Amendment to the Application to the
North Dakota Public Service Commission
for
Consolidated Certificate of Corridor
Compatibility and Route Permit

Case No: PU-11-696

**AVS-Neset 345-kV
Transmission Project**

January 2015

Figure 5.2-1
 Basin Electric Power Cooperative
 Antelope Valley Station to Neset
 345-kV Transmission Project
 Federal and State-Owned Lands

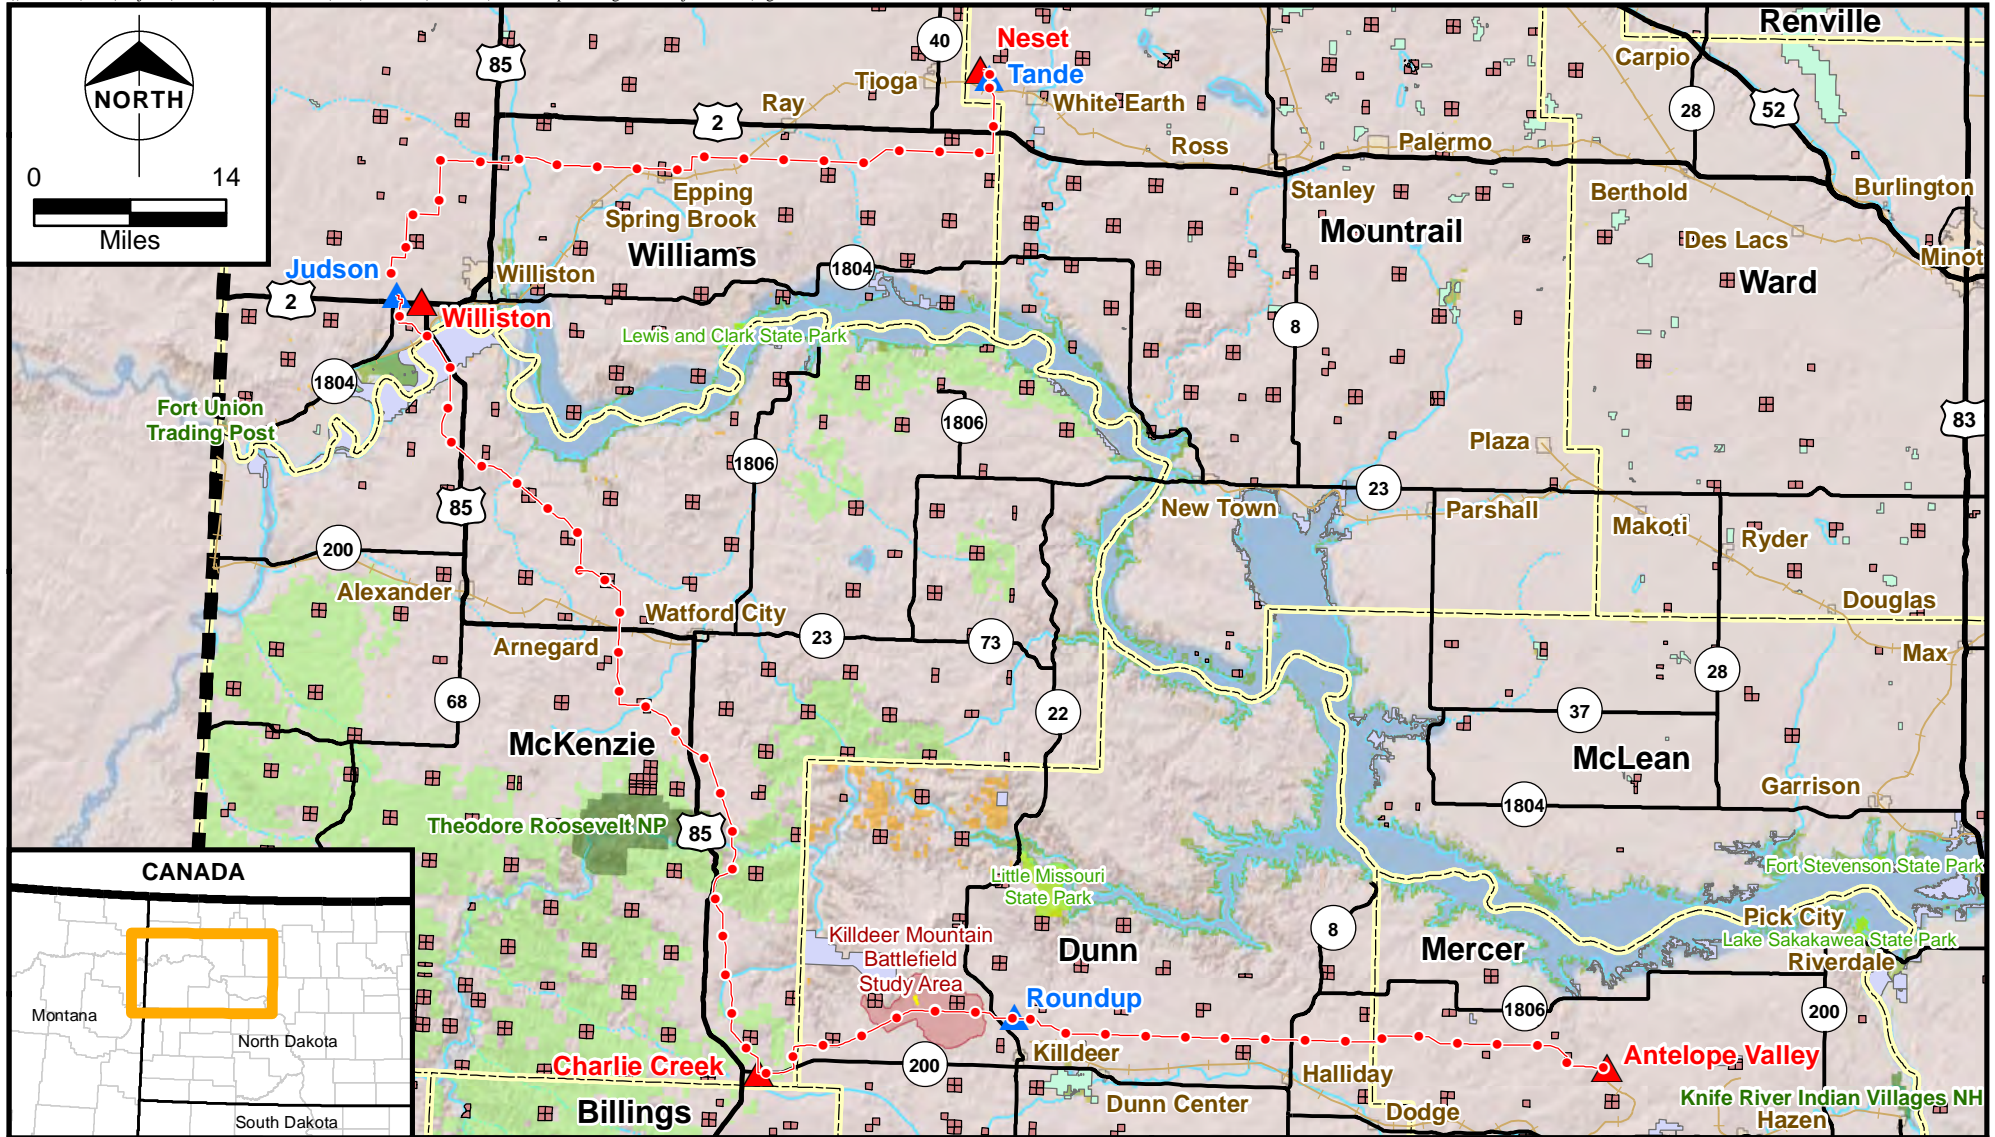
No changes from addition of proposed Roundup Substation. Figure 5.2-1 updated to include the Roundup Substation.

Figure 5.3-1
Basin Electric Power Cooperative
Antelope Valley Station to Neset
345-kV Transmission Project
Transportation and Utilities

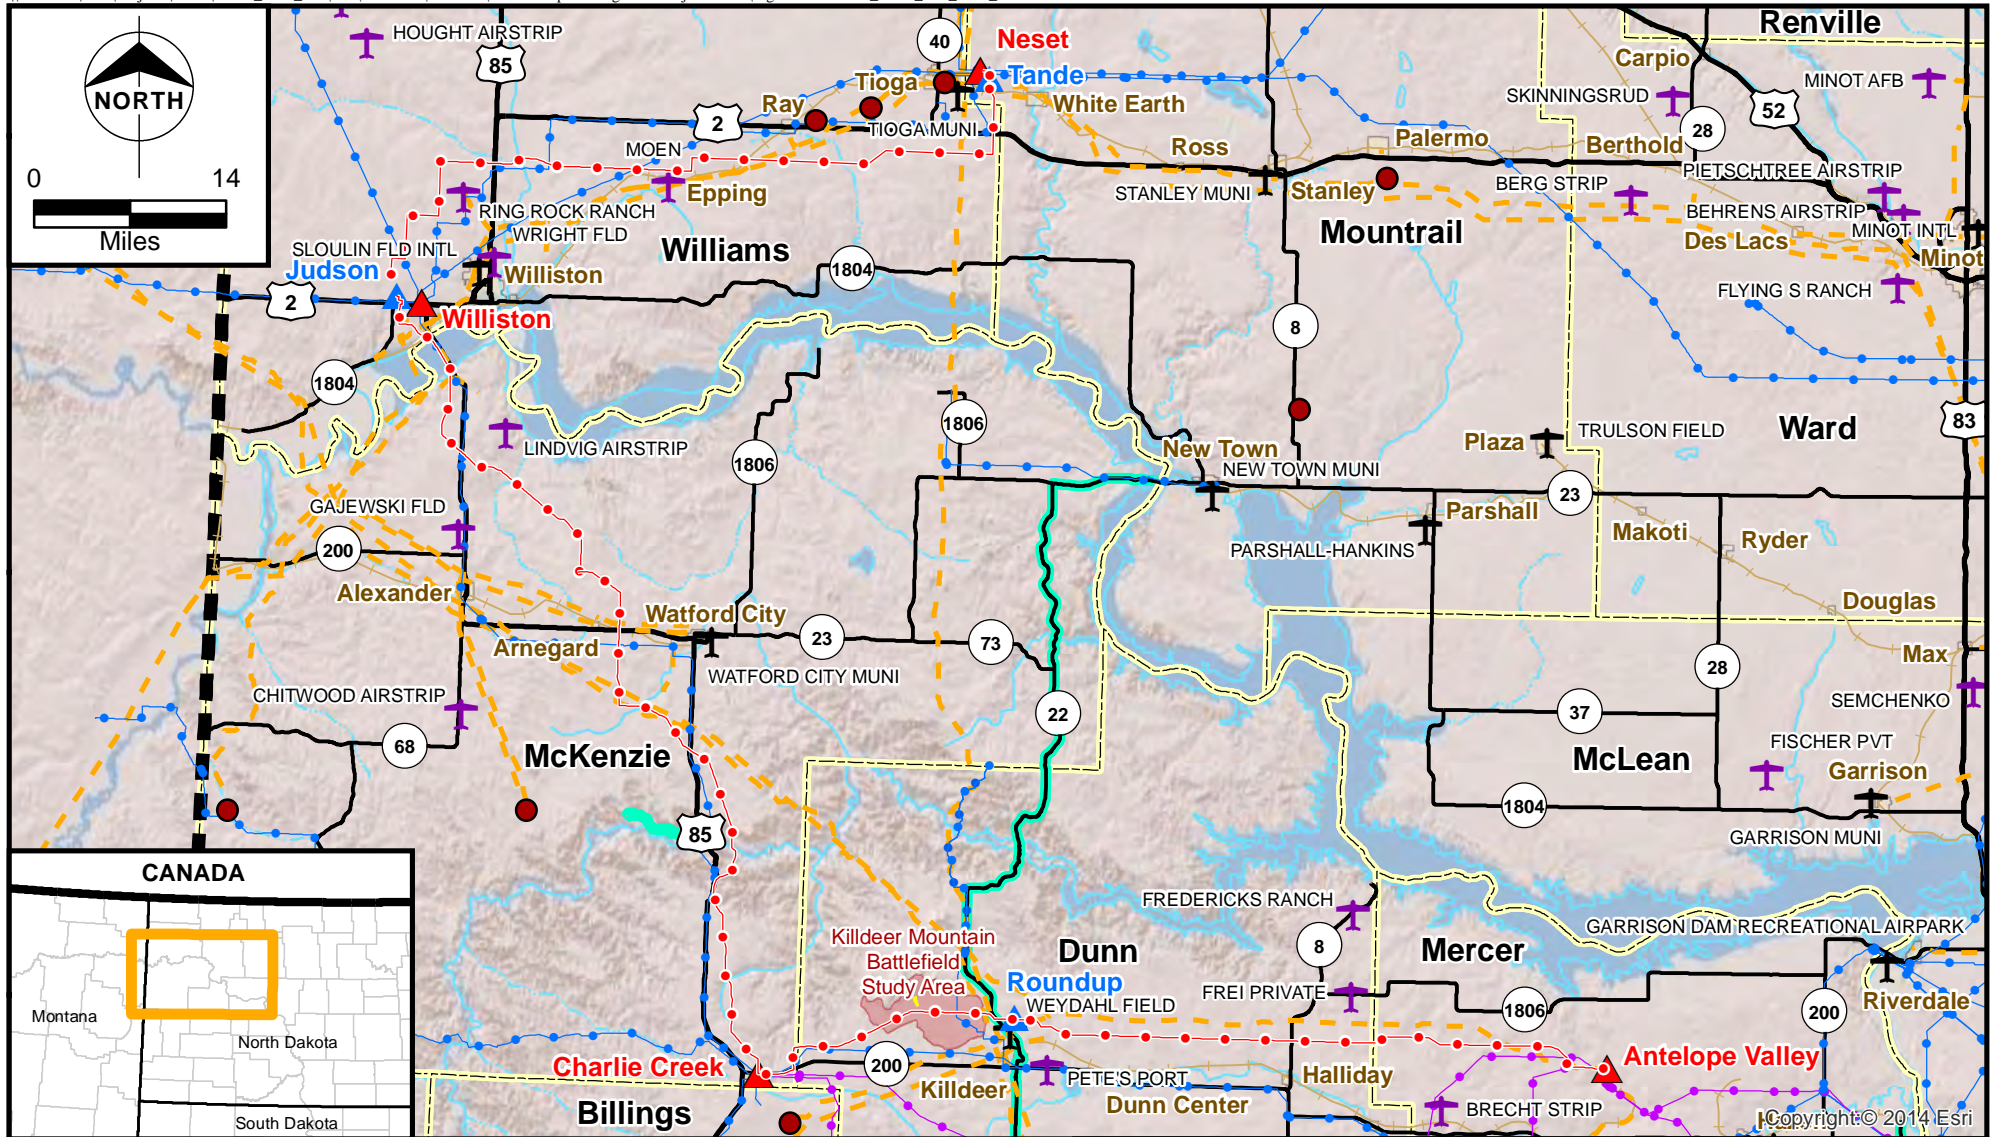
No changes from addition of proposed Roundup Substation. Figure 5.3-1 updated to include the Roundup Substation.

Figure 5.9-1
Basin Electric Power Cooperative
Antelope Valley Station to Neset
345-kV Transmission Project
Recreation Areas

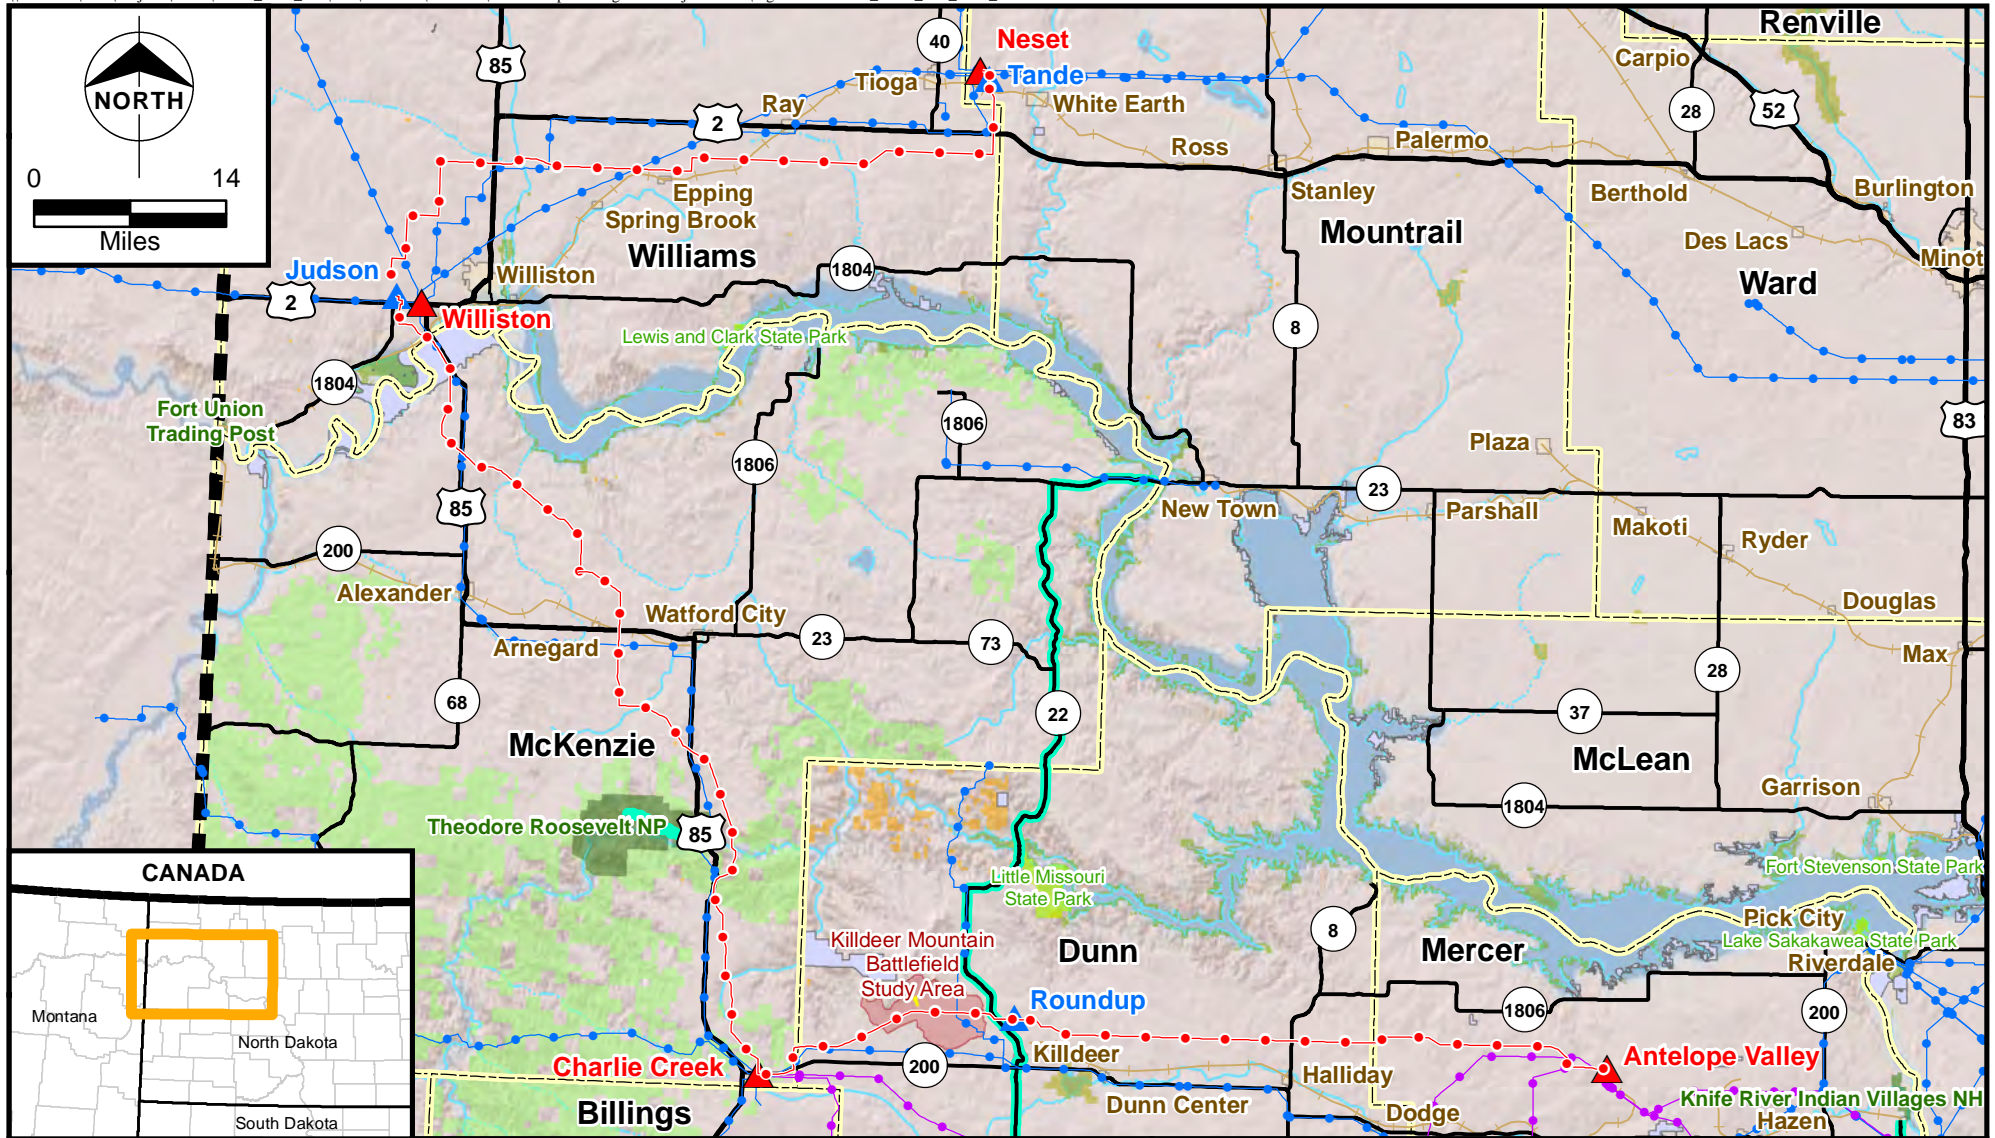
No changes from addition of proposed Roundup Substation. Figure 5.9-1 updated to include the Roundup Substation.

Figure 5.10-1
 Basin Electric Power Cooperative
 Antelope Valley Station to Neset
 345-kV Transmission Project
 Prime and Important Farmland

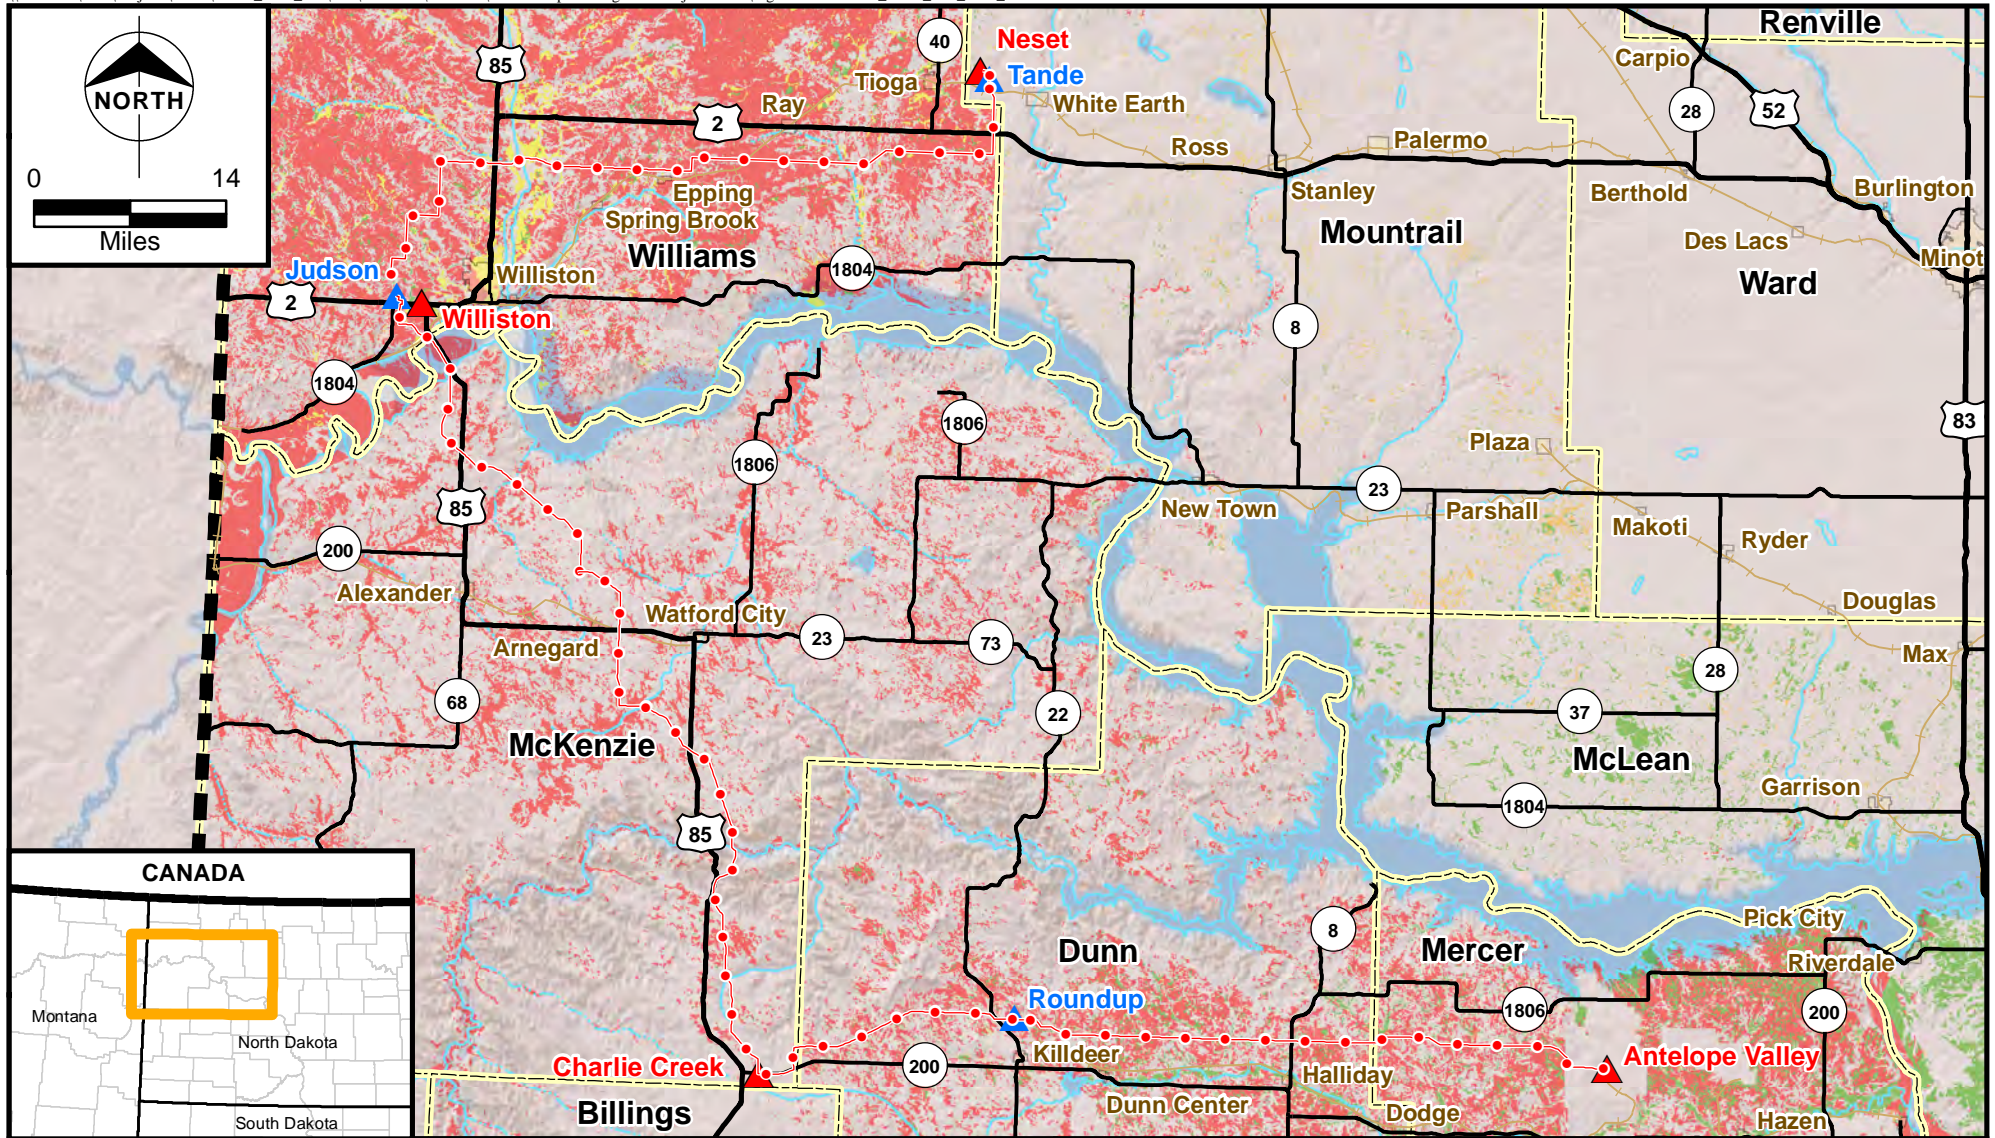
No changes from addition of proposed Roundup Substation. Figure 5.10-1 updated to include the Roundup Substation.

Figure 5.11-1
Basin Electric Power Cooperative
Antelope Valley Station to Neset
345-kV Transmission Project
Ecoregions within the Study Area

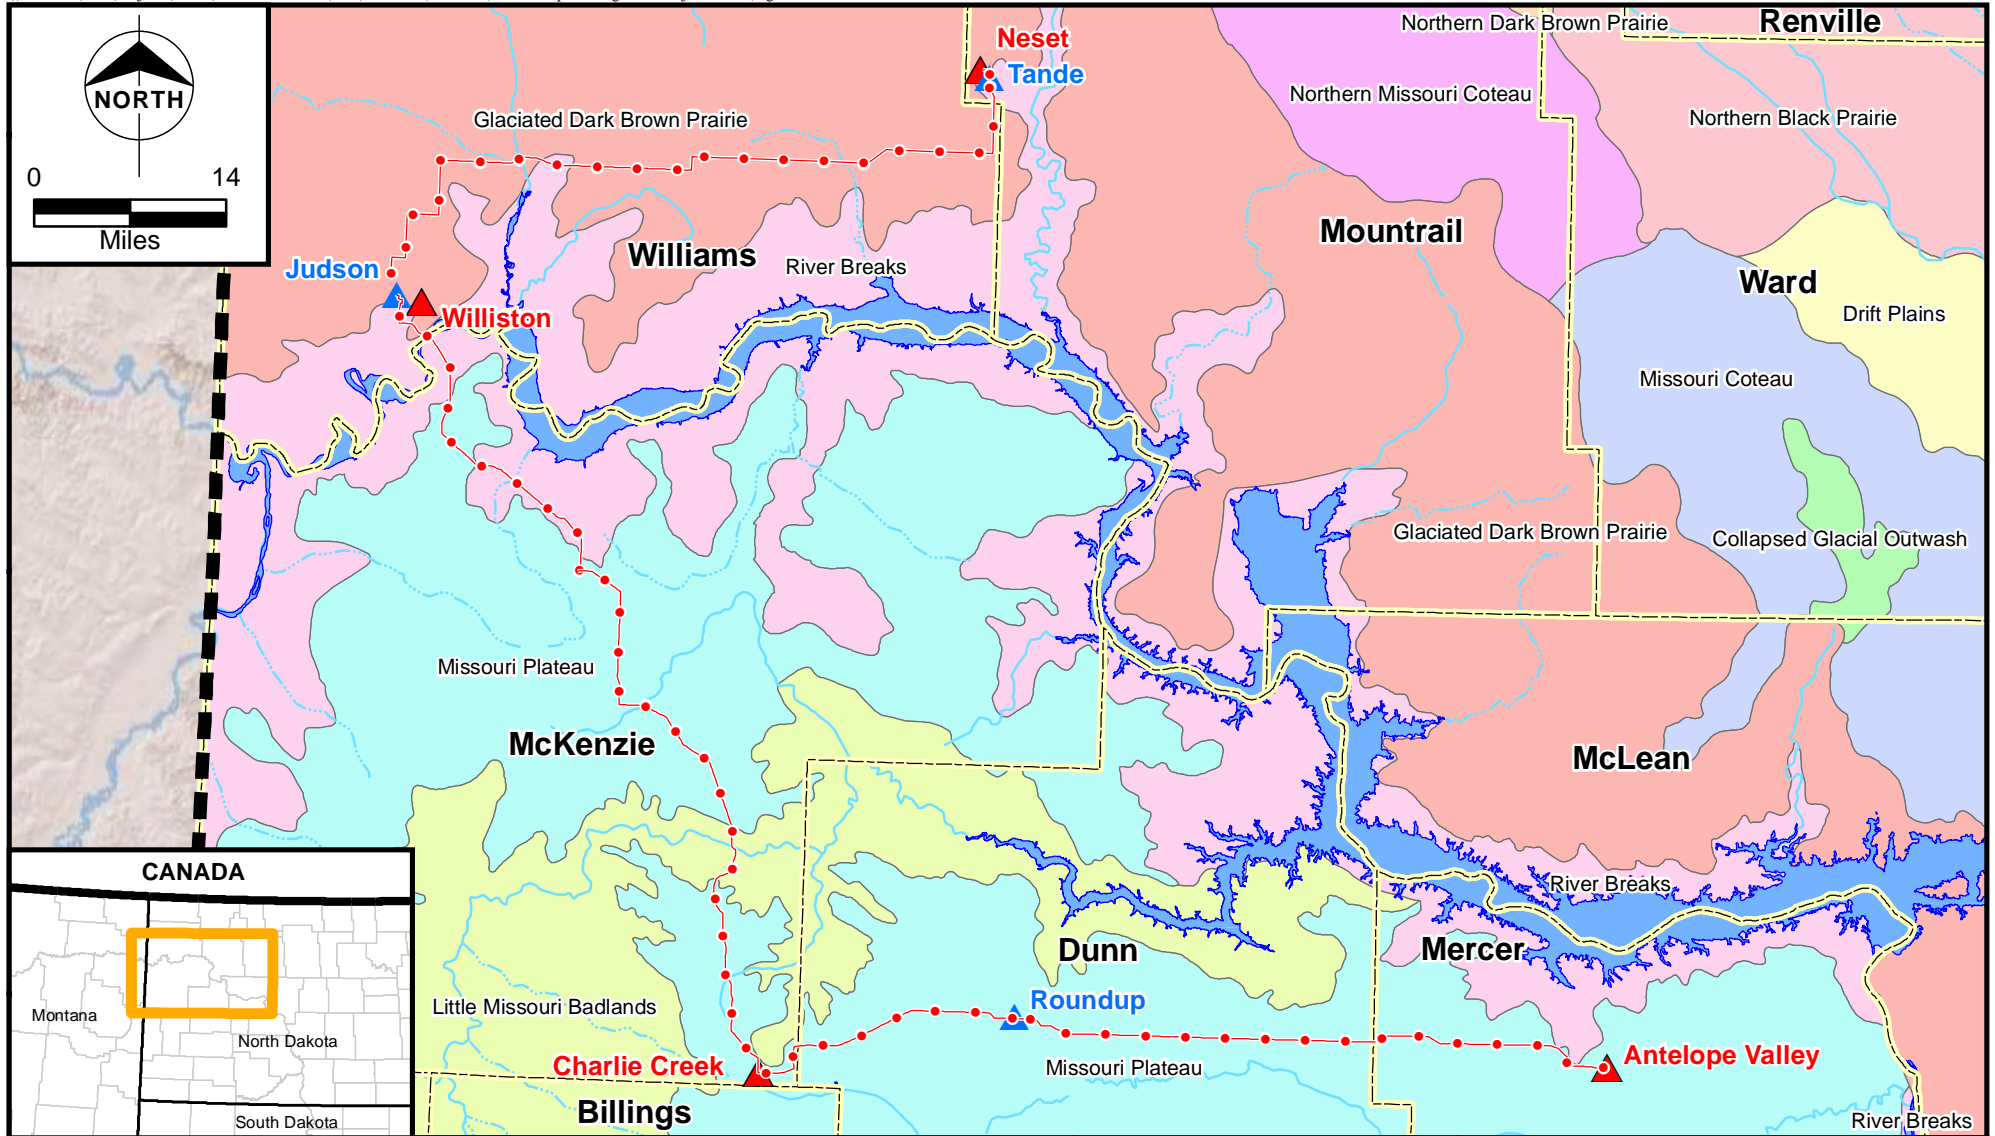
No changes from addition of proposed Roundup Substation. Figure 5.11-1 updated to include the Roundup Substation.
